Service Bulletin

Bulletin No.: PIC5884B

Subject: Trunk Lid Does Not Self Raise Completely

Models: 2014 Chevrolet Impala

3530798

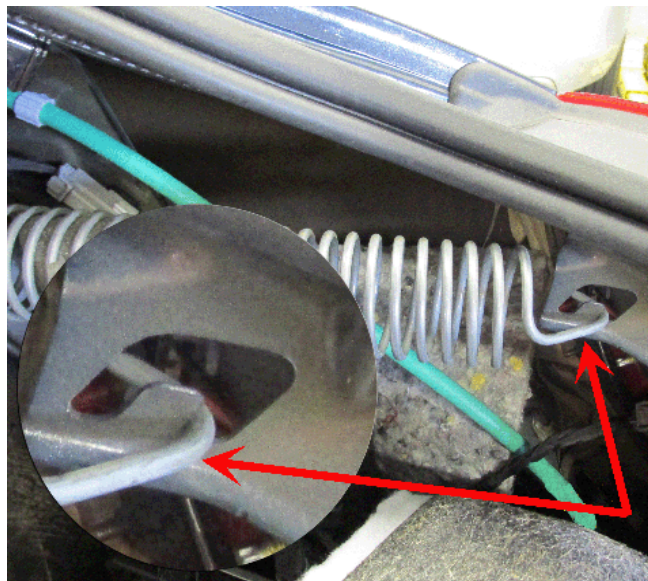
It may be noticed that the Trunk lid does not self-raise to the full upright position when released. This applies only to vehicles with Factory Installed Rear Spoilers or Dealer Installed GM Accessory Rear Spoilers prior to January 1, 2014.

Note: On January 1, 2014 the instruction sheet for the Dealer-Installed GM Accessory Rear Spoiler was updated to include the lift springs to be located to the rear-most position.

Assure that both trunk lift springs are in the rear-most position, as shown below. Refer to Service Information for the Rear Compartment Lid Hinge Spring Replacement.
